AMTA Submission

Remaking the low interference potential devices class licence— consultation

Figure 1—Transmit spectral power mask for 6 GHz WAS/RLAN [source: ETSI EN 303 687]

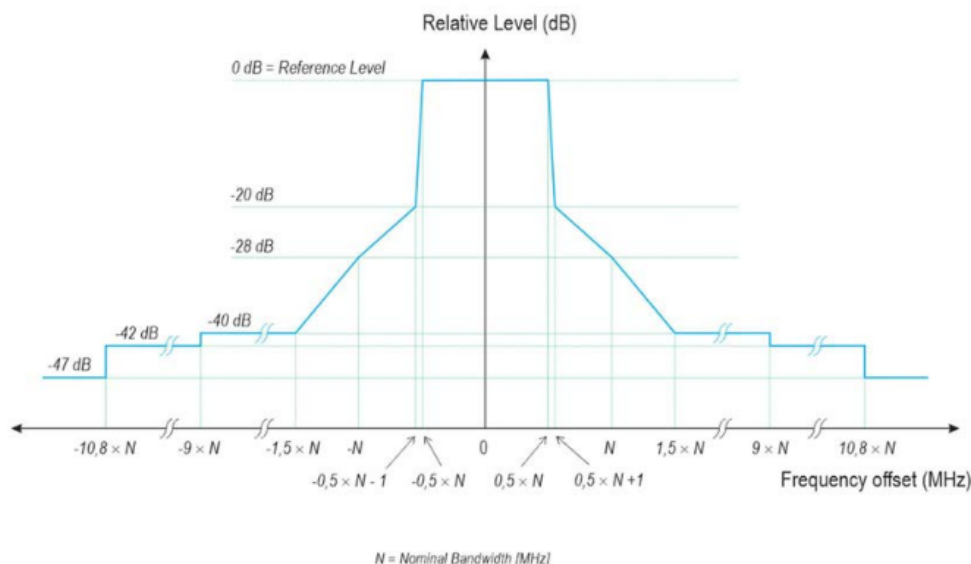
- The *transmitter unwanted emissions within the 6 GHz WAS/RLAN band* in clause 4.3.4.3 the OOB are required to drop to -20 dB (relative to in-band levels) within 1 MHz of the channel edge, but then take an entire channel width to reduce to -40 dB.
- Receiver selectivity parameters show that an adjacent-band interfering signal up to $P_{min} + 26$ dB needs to be tolerated, although it doesn't specify a co-channel requirement to compare this to, to be able to derive a single adjacent-channel selectivity (ACS) ratio value.

We note that the ACMA is not even proposing to specify OOB or receiver performance requirements in clauses 48 and 49 of the draft LIPD Class licence 2025. While we believe that they should be specified, we are not endorsing the current ETSI standardised values outlined in the dot

points above. Rather, these would need to be the output of international standardisation efforts, in turn following international studies on adjacent-band coexistence.
